**AREA 3 FIELD SAMPLING PLAN**  
**ADDENDUM TO REMEDIAL INVESTIGATION**  
**WORK PLAN**  
**FOR PER- AND POLYFLUOROALKYL SUBSTANCES**  
**(PFAS)**

**FORMER FORT DEVENS ARMY INSTALLATION, DEVENS, MA**

**JULY 2020**

Figure 2

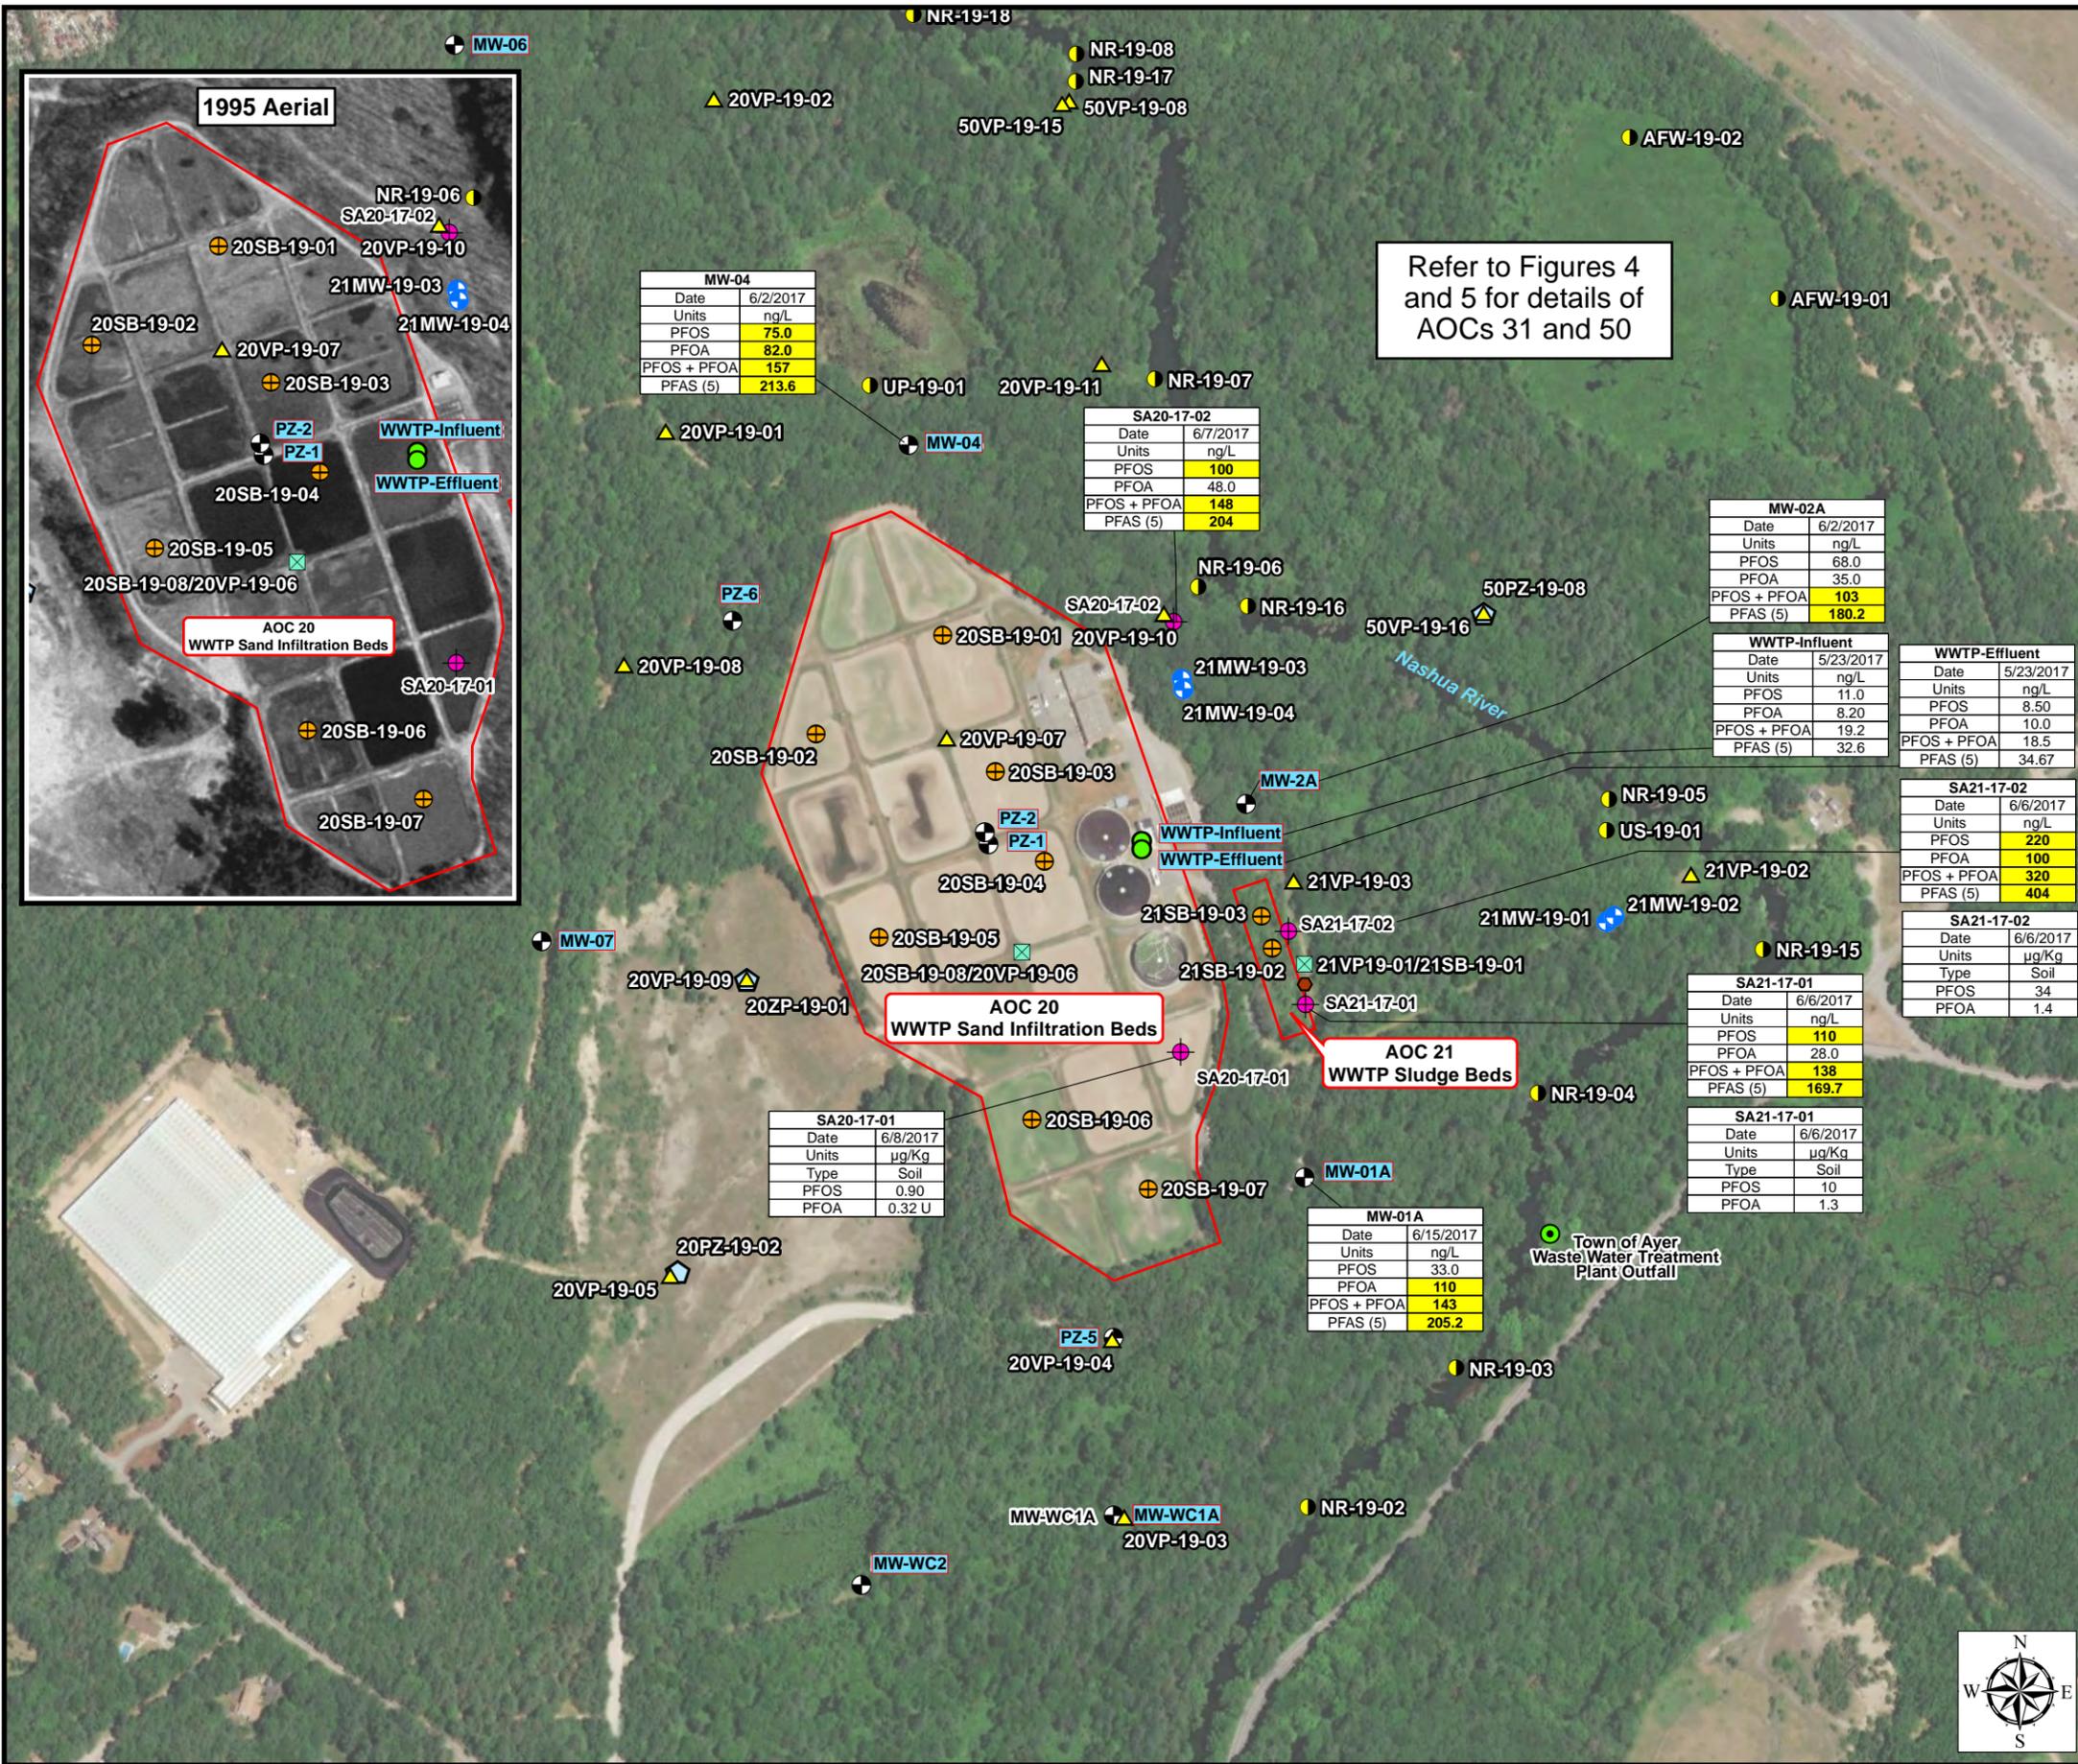
19. Figure 2 – Please add the additional vertical profiles locations requested in Page-Specific Comment 14 above.

20. Figure 2 – Please add the additional surface water and sediment sample locations requested in Page-Specific Comment 17 above.

**Comment #3:** Figure 2: The location of the Ayer WWTP outfall should be determined with the same accuracy used to locate the surface water and sediment samples (e.g., GPS survey).

**Comment 17.** Figure 2 – As discussed in Comment 5. above, Army's proposed field sampling activities around the filtration beds will leave spatial data gaps that will likely have to be addressed with additional vertical profile locations. Army previously responded that it has assumed exceedances of the PFAS LHA all the way to the river on the east, but there are no investigations planned east of the river. West of the infiltration beds the profile spacing is 1000 feet. Once the current locations are sampled the locations for the additional vertical profiling on the west to close the data gaps can be determined. Based on the available data, the hydrologic control on the west is inadequate. A SW/SED sample at the inside bank on the river bend is needed. Sampling of the Town of Ayer WWTP discharge would be appropriate.

**Comment 2.** Figure 2 – Neither WC-1A nor WC-2 are deep enough to monitor for PFAS that been detected at 20VP-19-03 and 20VP-19-04. These are water table wells extending to 19 feet bgs whereas PFAS has been detected in excess of the LHA from 19 to at least 58 feet bgs at the two vertical profiles. More appropriately screened wells are required south of the filter beds.

**Comment 3.** Figure 2 – EPA notes a lack of adequate water level control and vertical profile data east of the filter beds. Without additional data it must be assumed that PFAS in excess of the LHA is present in groundwater from the filter beds to the river and perhaps beyond the river.

**Comment 4.** Figure 2 – Once all the vertical profile data for this site has been reported, especially west of the filter beds, additional data gaps may become apparent. Note 20ZP-19-01 should be 20PZ-19-01.

**Response:** The location of the Ayer WWTP outfall was identified and was posted on figure 2 in the final FSP.

**Army Response 01/17/20:** Yes, the former infiltration beds were located immediately adjacent to the current, existing infiltration beds. The current treatment plant structures, shown on the east side of the current infiltration beds on Figure 2, were constructed on top of four of the former infiltration beds. The other beds remain unchanged. The current and former operations and infiltration beds at the waste-water treatment plant will be considered as part of the data evaluation. A historic photograph, that shows the historic infiltration beds, has been added to Figure 2.

**Army Response 01/17/20:** Prior to 1985, the supernatant was discharged to the wetland east of the sludge drying beds. This approximate location was added to Figure 2.

Figure  
3

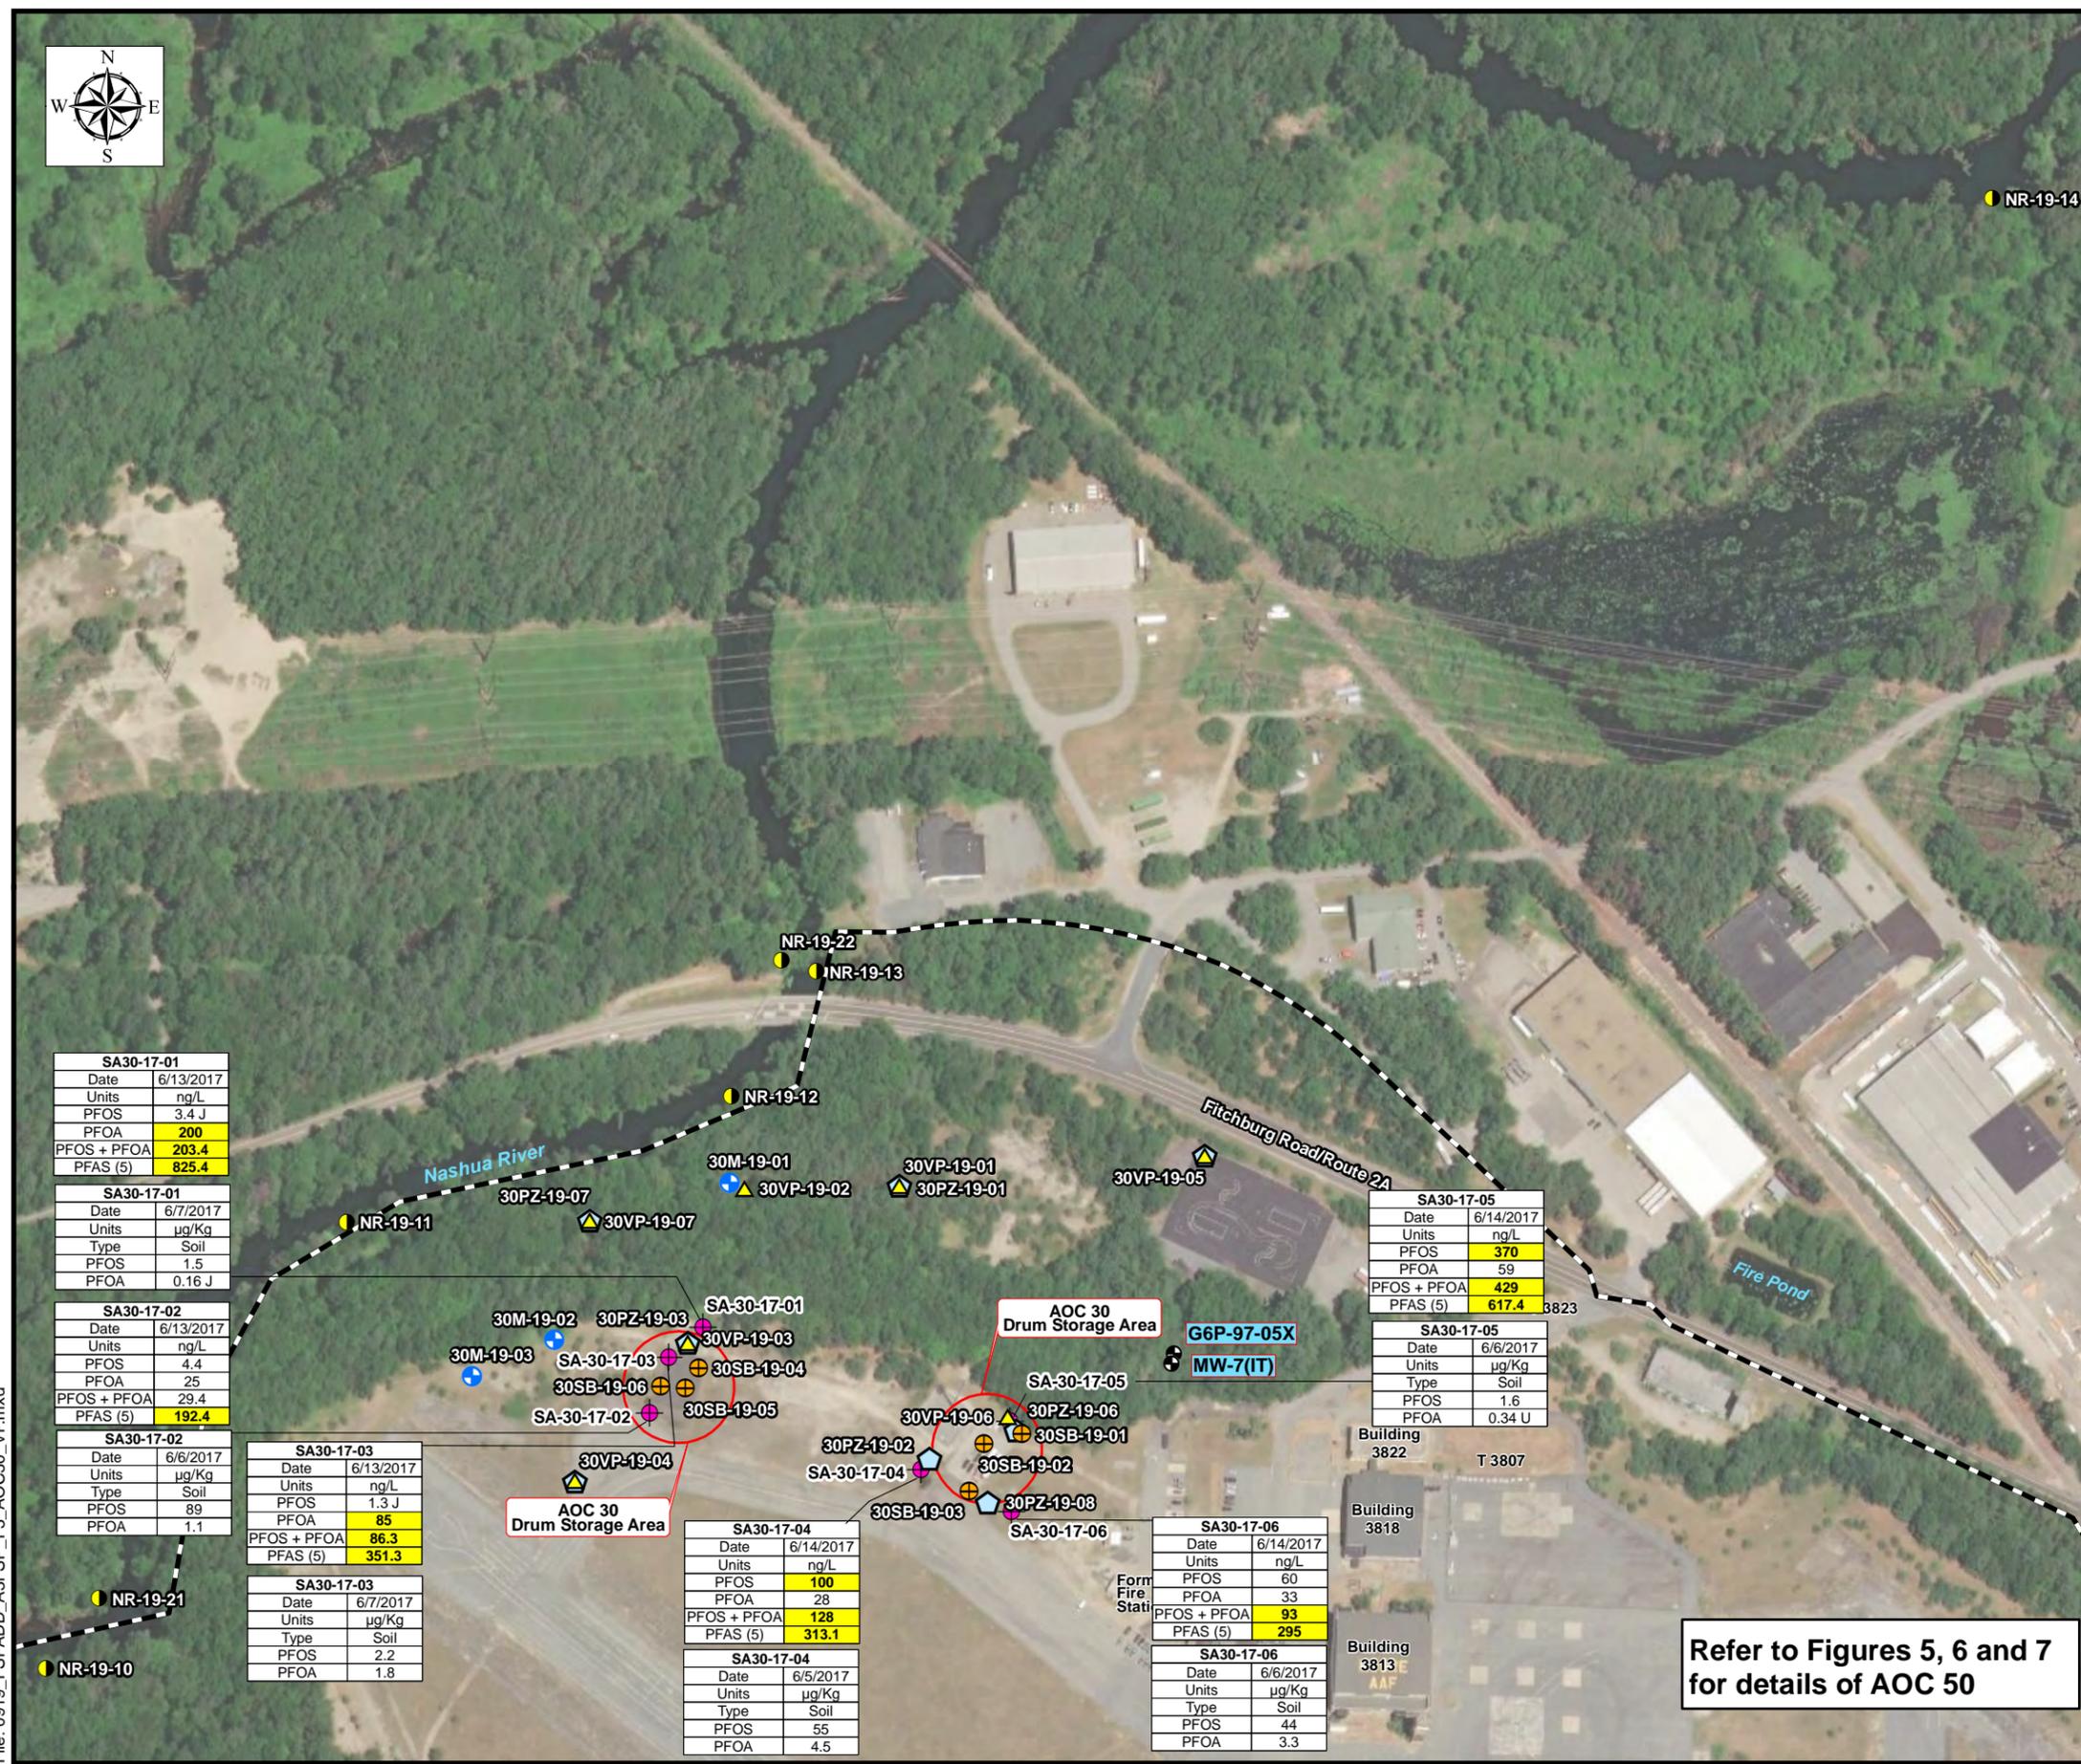
21. Figure 3 – Please add the additional piezometers requested in Page-Specific Comment 13 above.

**Comment #4:** Figure 3: The proposed scope of investigation for AOC 30 is insufficient to characterize groundwater beneath either storage area. As indicated in Section 5.2.1 (and discussed during the 11 October 2018 conference call), groundwater flow directions in both areas are not known. In addition, PFAS concentrations upgradient, downgradient, and vertically within the aquifer should be determined in both areas to pin-point source locations, target soil samples, and determine the contribution of each source to more extensive contamination that may originate at upgradient locations. To close these datagaps:

**SC Comment #5:** Figure 3 – (Western Storage Area.) The plan should identify well screen intervals (depths/elevations and target water-bearing strata) of the piezometers or monitoring wells and provide some rationale for those intervals based on the depths where PFAS are encountered in the Western Storage Area. Vertical profiling should be considered to characterize the vertical distribution of PFAS.

**SC Comment #6:** Figure 3 – (Eastern Storage Area.) The plan should identify well screen intervals (depths/elevations and target water-bearing strata) of the piezometers or monitoring wells and provide some rationale for those intervals based on the depths where PFAS are encountered in the Eastern Storage Area. Vertical profiling should be considered to characterize the vertical distribution of PFAS.

**Comment 18.** Figure 3 – While EPA understands re access concerns closer to the river; however, it is expected to be necessary to collect data closer to the river to define the magnitude and extent of PFAS contamination and the potential impact on the river. Also, the piezometer would preferably be installed closer to the river. Investigation west of the river is also expected to be a component of this investigation. Collect SW/SED on the inside bank of the sharp river bend.

**Comment 1.** Figure 3: The scope of the proposed investigation is insufficient to determine whether the AOC 30 storage areas are active sources of PFAS contamination in groundwater. Significant datagaps will exist if site-specific groundwater flow directions, upgradient and downgradient PFAS concentrations, and the vertical extent of contamination at each storage area are not determined. The Army is aware of this concern, and has responded previously (e-mail dated October 1, 2019), indicating that the proposed work may be sufficient to characterize these areas. MassDEP disagrees for the reasons given previously (e-mail dated December 7, 2018).

**Comment 5.** Figure 3 – Another piezometer is required south of NR-19-11 and west of the western drum storage area to better define the groundwater flow direction and for better placement of the proposed wells 30M-19-02 and 30M-19-03.

**Comment 6.** Figure 3 – Wider spacing of the three piezometers at the eastern drum storage areas would be appropriate to better define water level differences.
